SERVICE BULLETIN

SERVICE BULLETIN #240

MODELS: WESTERBEKE 71C/FOUR AND 82B/FOUR

SUBJECT: DOMESTIC WATER HEATER CONNECTION CHANGE

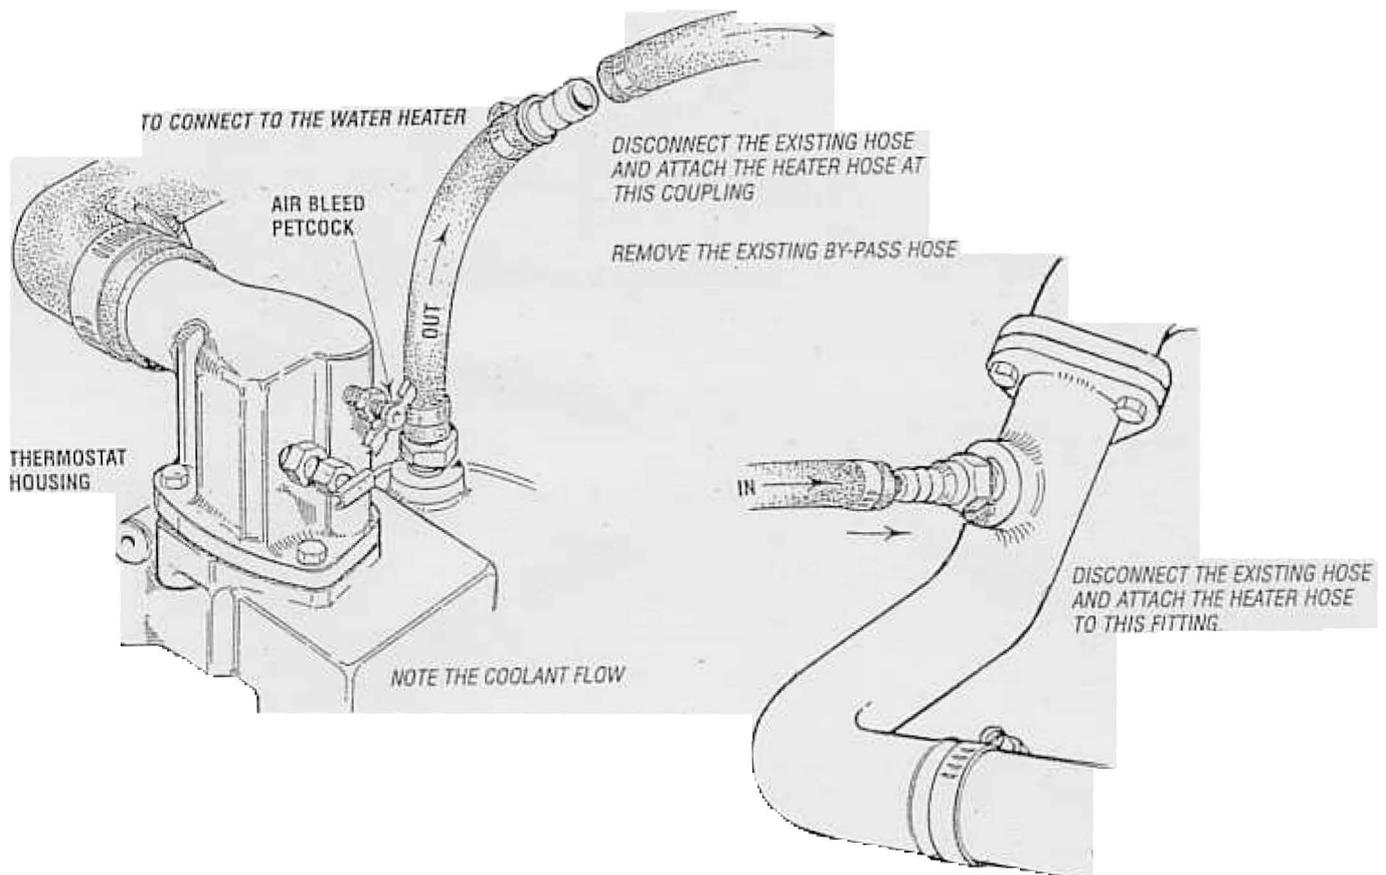
TO PROVIDE BETTER ENGINE COOLANT FLOW TO DOMESTIC WATER HEATERS A BY-PASS CONNECTION HAS BEEN CREATED BETWEEN THE LOWER AREA OF THE ENGINE THERMOSTAT AND THE INLET TO THE FRESHWATER CIRCULATING PUMP.

THE ILLUSTRATION BELOW SHOWS THIS NEW BY-PASS. TO CONNECT A DOMESTIC WATER HEATER SIMPLY REMOVE THE 5/8 I.D. BY-PASS HOSE AND CONNECT THE WATER HEATER TO THE TWO FITTINGS THE ILLUSTRATION SHOWS.

WHEN THE DOMESTIC WATER HEATER IS LOCATED HIGHER THAN THE ENGINE'S COOLING SYSTEM PRESSURE CAP A REMOTE EXPANSION TANK KIT PN#024177 MUST BE INSTALLED. FOLLOW INSTALLATION INSTRUCTIONS FOR THIS KIT FOUND IN THE OPERATOR'S MANUAL PUBLICATION #038922 PAGES 66 & 67.
